**ADDENDUM No. 3 TO THE
FINAL ENVIRONMENTAL IMPACT REPORT
Carpinteria Valley Water District's
Water Storage Tank Project
And Rancho Monte Alegre Annexation**

September 12, 2007

CARPINTERIA VALLEY WATER DISTRICT RANCHO MONTE ALEGRE WATER FACILITIES PROJECT	PROJECT NUMBER 12207A
REVISED DETENTION BASIN OUTFALL DETAILS	DRAWING NUMBER 15-C-08
	SHEET NUMBER 15 OF 33

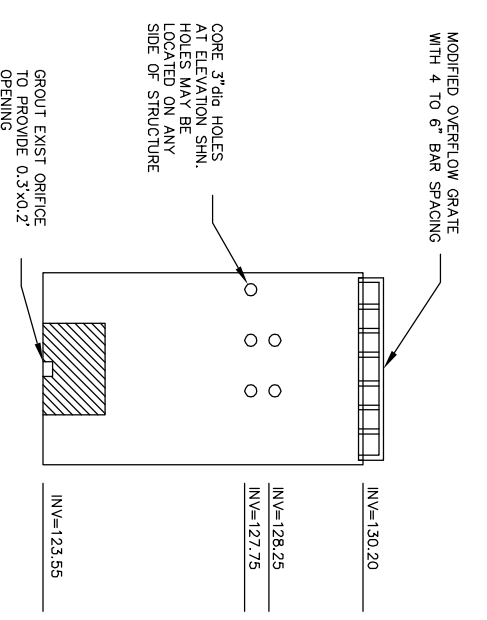
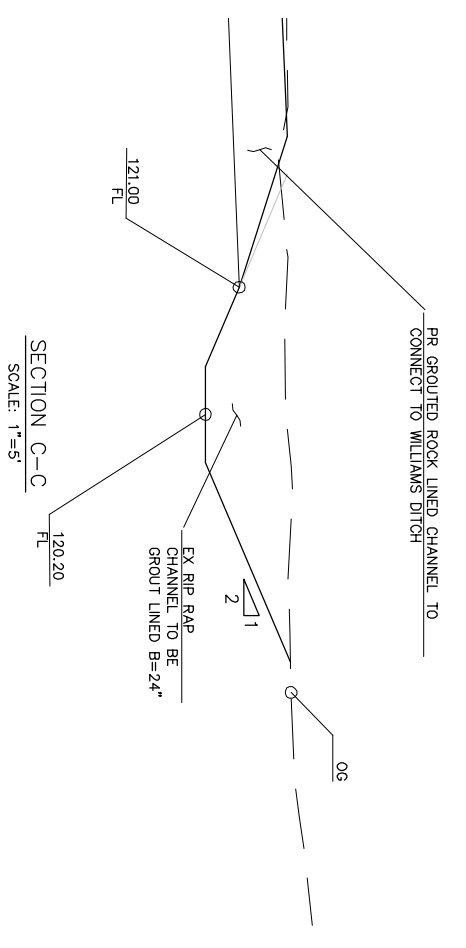
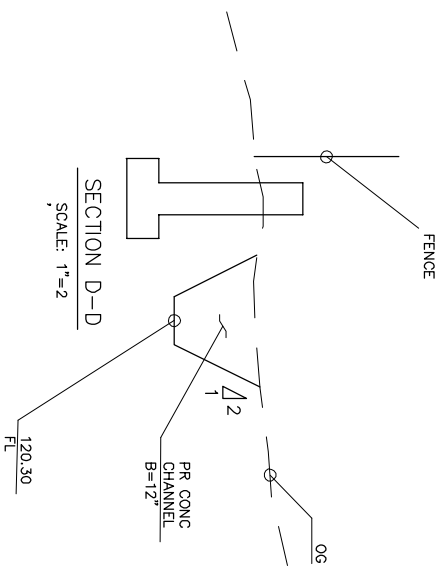
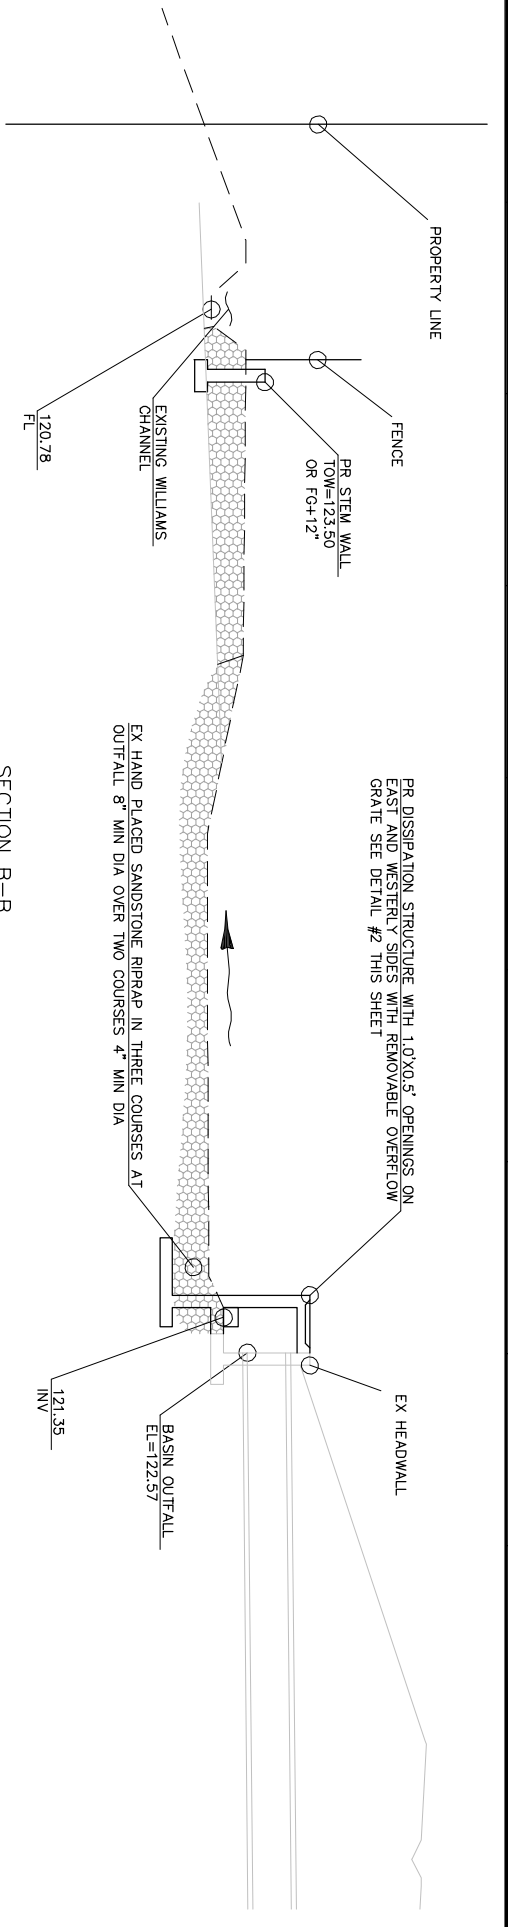
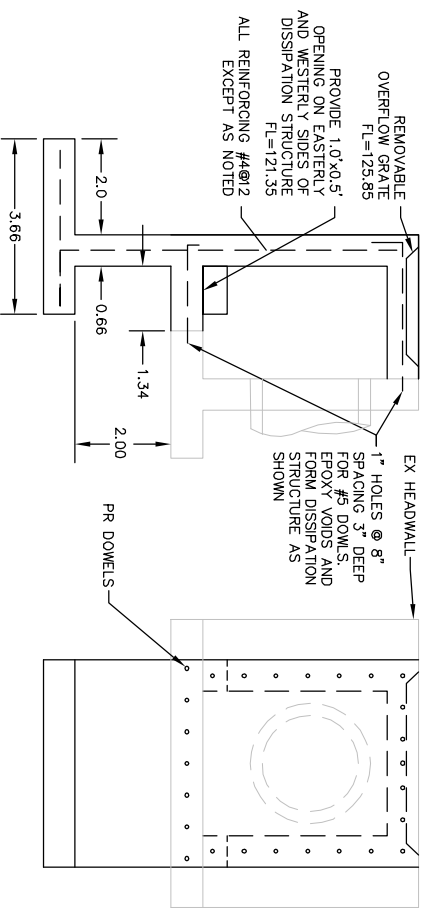
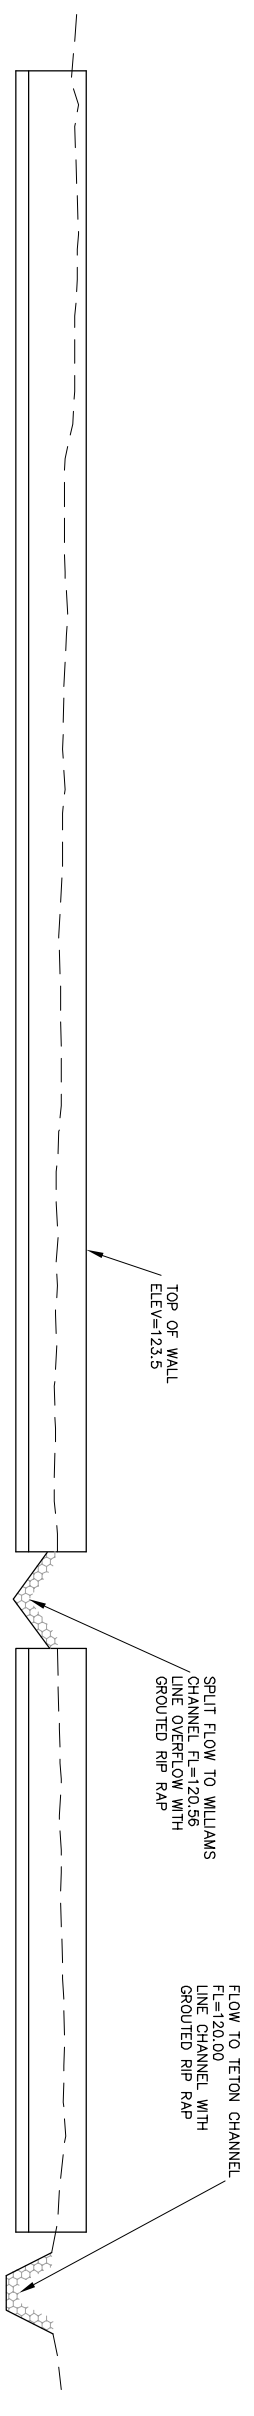
Further, revisions to the detention basin as it existed in August 2006 were completed to optimize the ponds effectiveness given a diversion proposed by RMA within the tributary drainage watershed (see drawing 15-C-08 provided in the Attachments Section of this Addendum). The pond outlet structure orifices were modified to this end. The outlet structure modifications included reducing the size of the lower orifice and adding additional orifices 3 to 5 feet above the lower orifice.

The pond outfall was modified with an energy dissipation structure that splits flows and direct it perpendicular to the pipe (see drawings 15-C-07 and 15-C-08 provided in the Attachments Section of this Addendum). The dissipation structure is a concrete box approximately three to four feet wide and tall with 12-inch by 6-inch rectangular openings on two sides.
